The Calcutta Gazette

WEDNESDAY, JULY 6, 1921.

NOTICES TO MARINERS.

Nagahama—Amendments to charts with regard to depths and shoals.

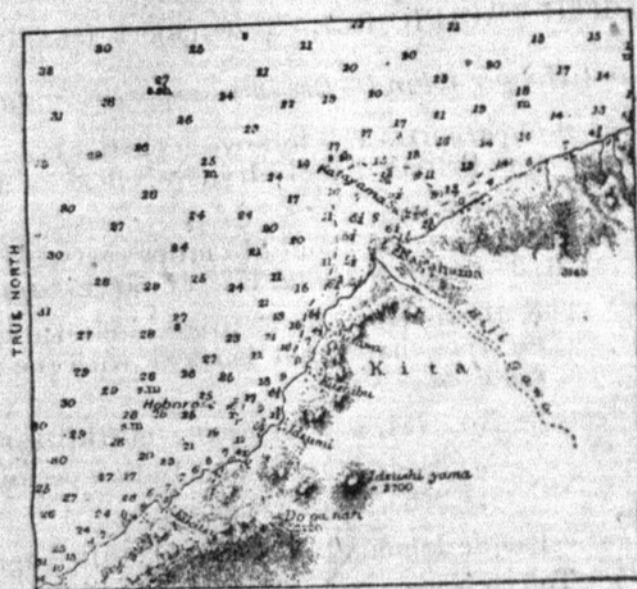
Details.—The accompanying reproduction of portions of charts Nos. 2875 and 1648 shows the necessary corrections to those charts with regard to depths, shoals and the coast line in the vicinity of Nagahama and approach.

Reproduction of Portion of Chart N°1070

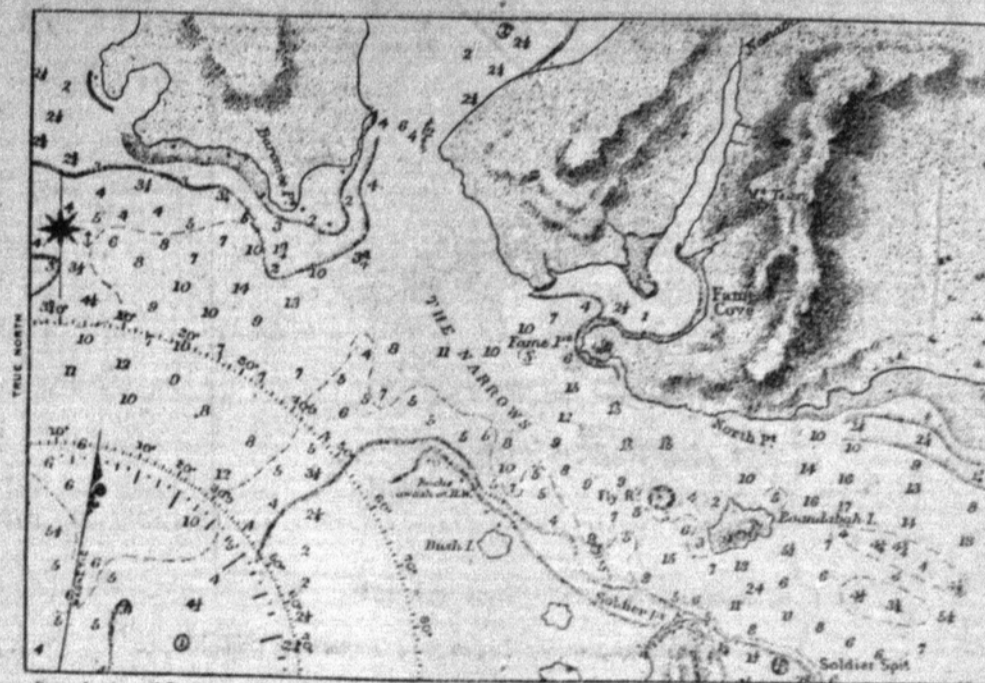
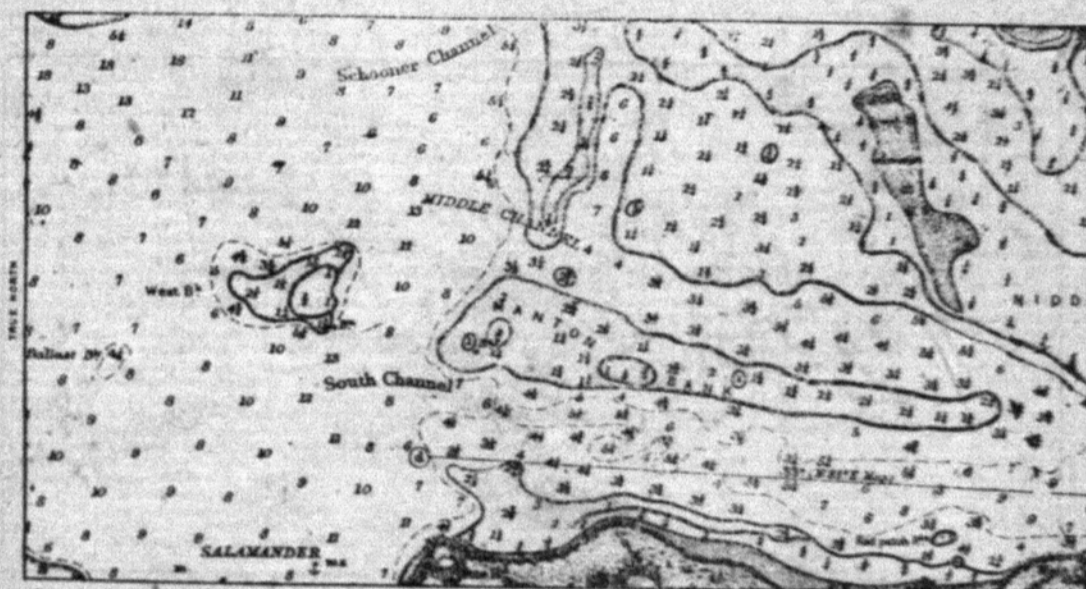
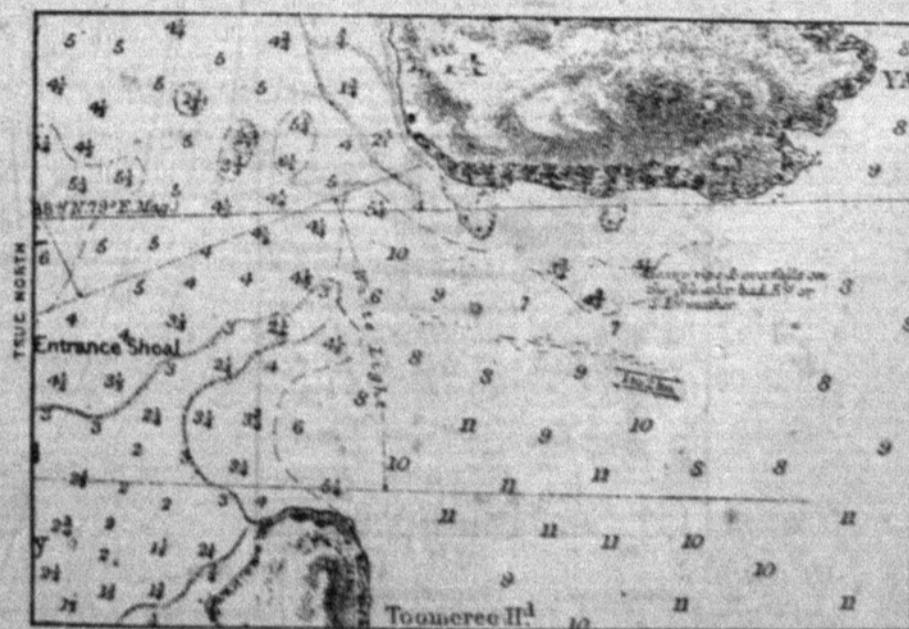
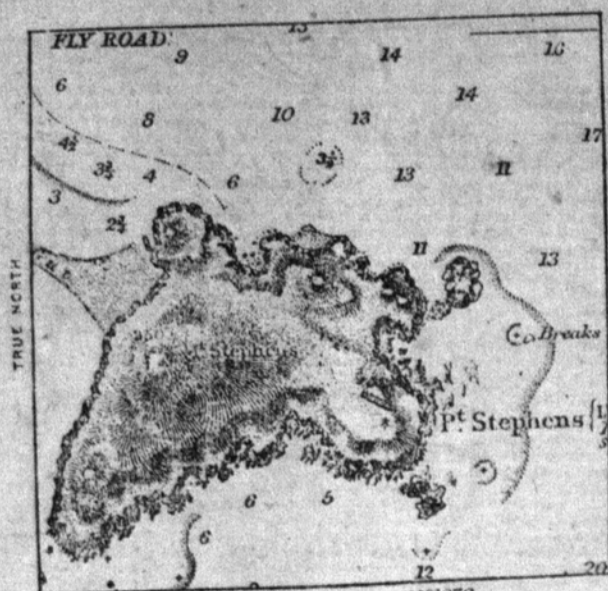
Details.—The accompanying reproductions of portions of charts Nos. 1070, 1021, 1024 and 3622 show the necessary corrections to those charts with regard to shoals, as revealed by a recent survey.

The following cautionary note is to be inserted on chart No. 1070:—

A recent survey shows the existence of a number of additional dangers outside the main channel; this chart must therefore be used with caution.

Reproduction of Plan on Chart N° 1899

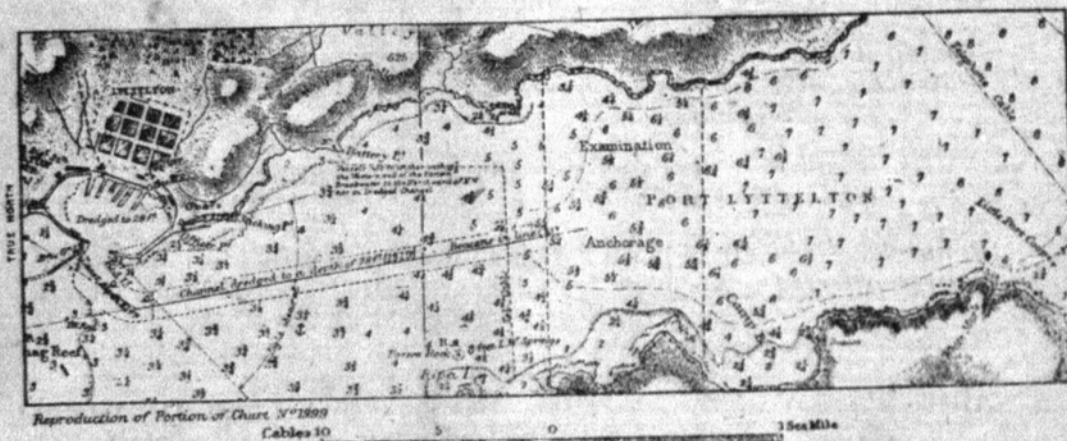
Details.—The accompanying reproductions of portions of chart No. 1999, show the necessary corrections to that chart with regard to the depths in Lyttelton harbour and the entrance channel.

Charts affected.—No. 2747, Entrance to Port Phillip.

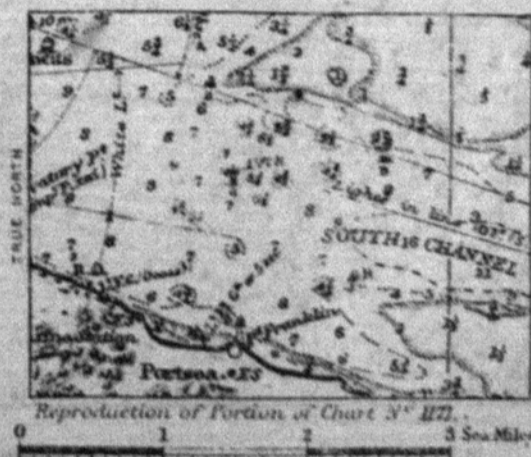
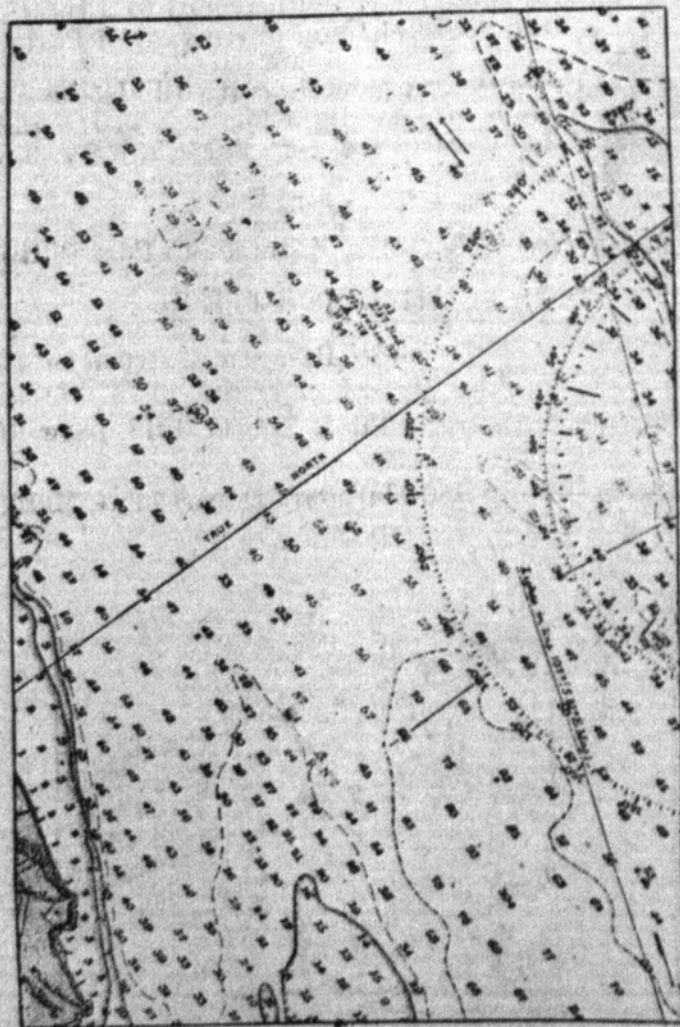
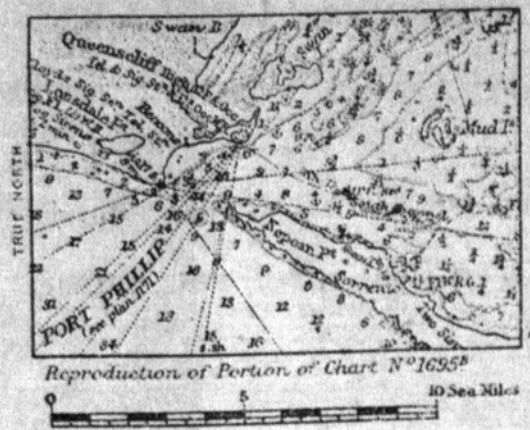
Details.—The accompanying reproductions of portions of charts Nos. 2747, 1171 and 1695b show the necessary correction to those charts with regard to alterations in depths in the South channel northward of Portsea.

From the reproductions it will also be seen that the positions of the light-buoy, Nos. 1, 2 and 3 buoys, and the buoy eastward of Portsea jetty have been slightly amended.

Charts affected.—No. 3720, Pontianak to Tanjong Bayung.

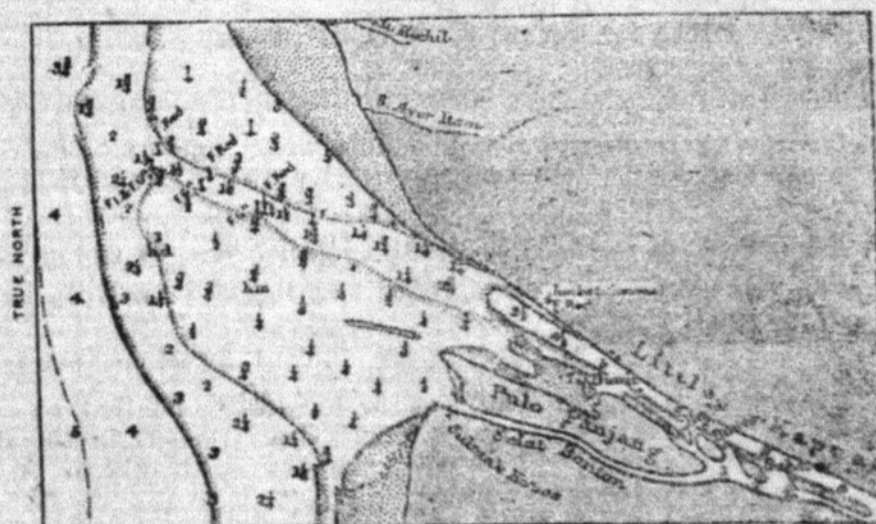
Details.—The accompanying reproduction of portions of charts Nos. 3720 and 3721 shows the necessary corrections to those charts with regard to depths, &c., in the entrance to Little Kapuas river, together with the amended position of the fixed red light at Junkat.

Charts affected.—No. 3440, Plan of Katapu anchorage.

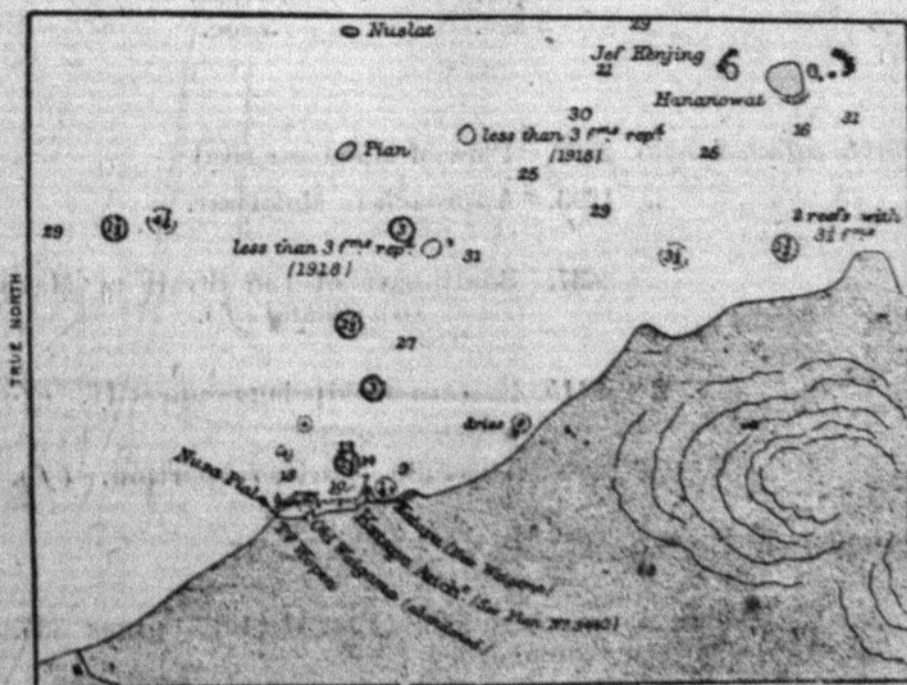
The inner $2\frac{1}{2}$ fathom shoal, which is situated at a distance of 13.05 cables, 063° , from the centre of Nusa Piai, is to be inserted on the plan of the abovementioned anchorage on chart No. 3440.

Reproduction of Portion of Chart N° 967

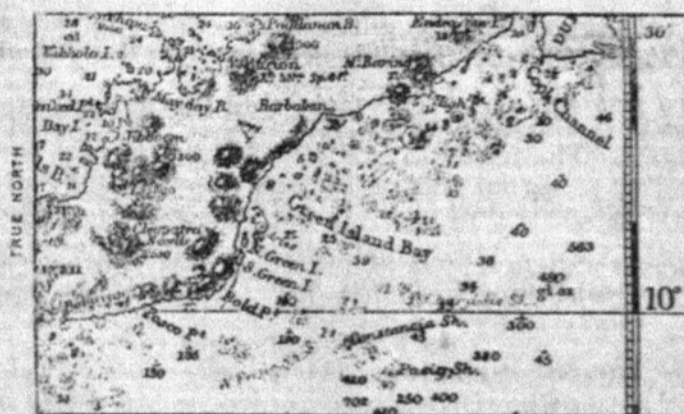
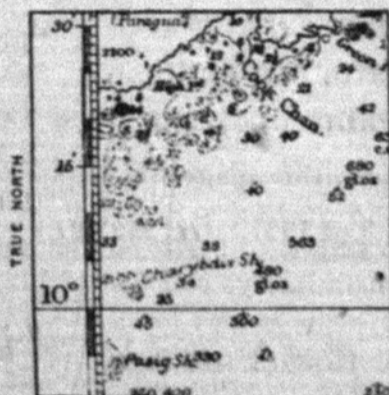
Details.—The accompanying reproductions of portions of charts Nos. 967, 2660b, 943, 2578 and 1263 show the necessary corrections to those charts with regard to reefs and shoals between Deep bay and Dumaran island.

Charts affected.—No. 1969, Ozuchi jima to Funoko sima.

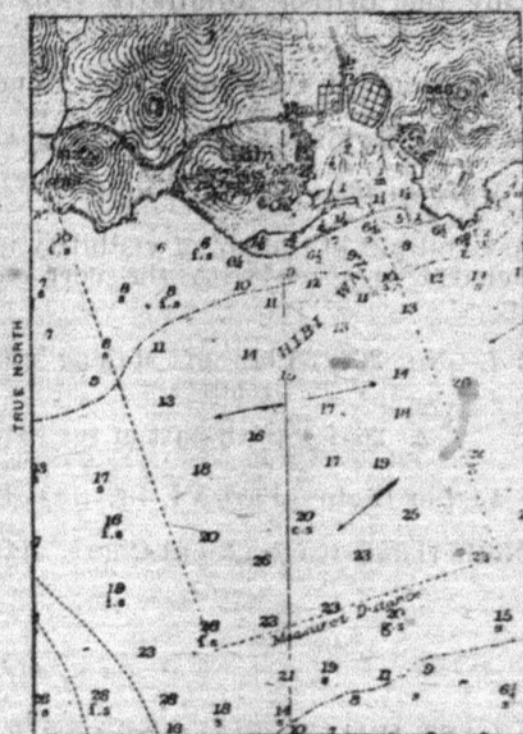
Details.—The harbour works at Hibi wan have now been completed and a measured distance, indicated by beacons, has been established as shown on the accompanying reproduction of portions of charts Nos. 1969 and 128.

Reproduction of Portion of Chart No. 1725

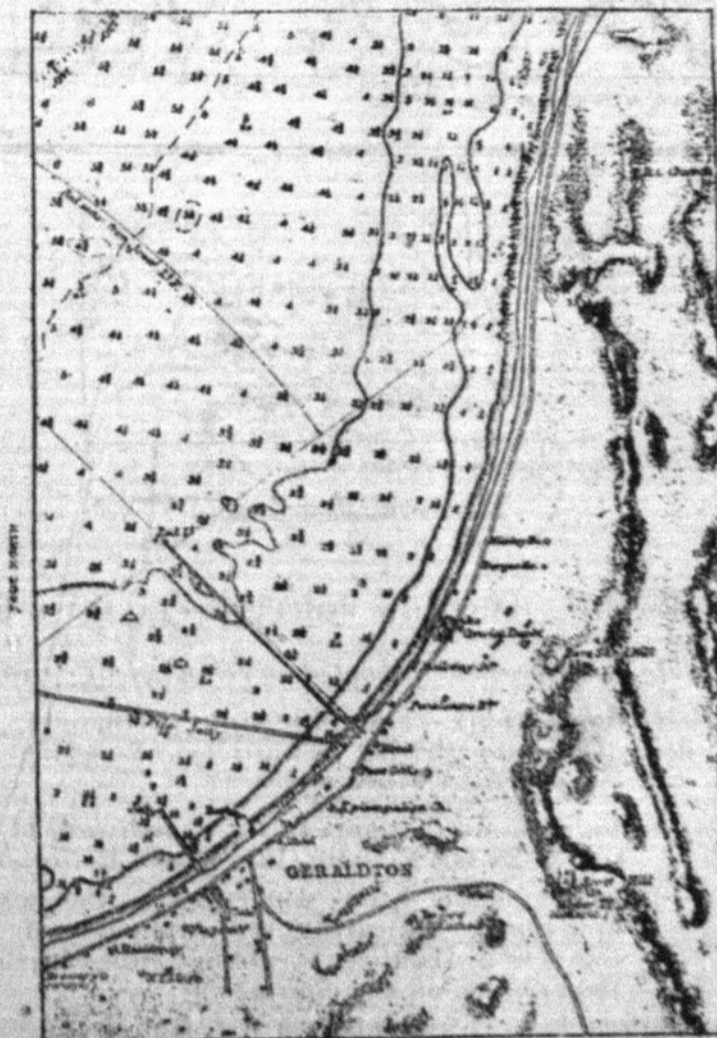
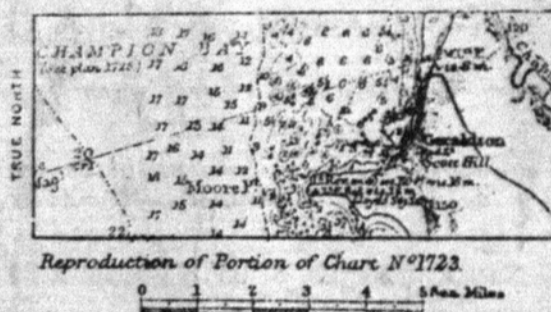
Details.—The accompanying reproductions of portions of charts Nos. 1725 and 1723 show the following:—

- (a) Amendments to charts with regard to shoals.
- (b) Extension of the North jetty and amended position of front leading light.
- (c) New pile jetty completed, from which a *green* light is exhibited.
- (d) Position of certain landmarks.
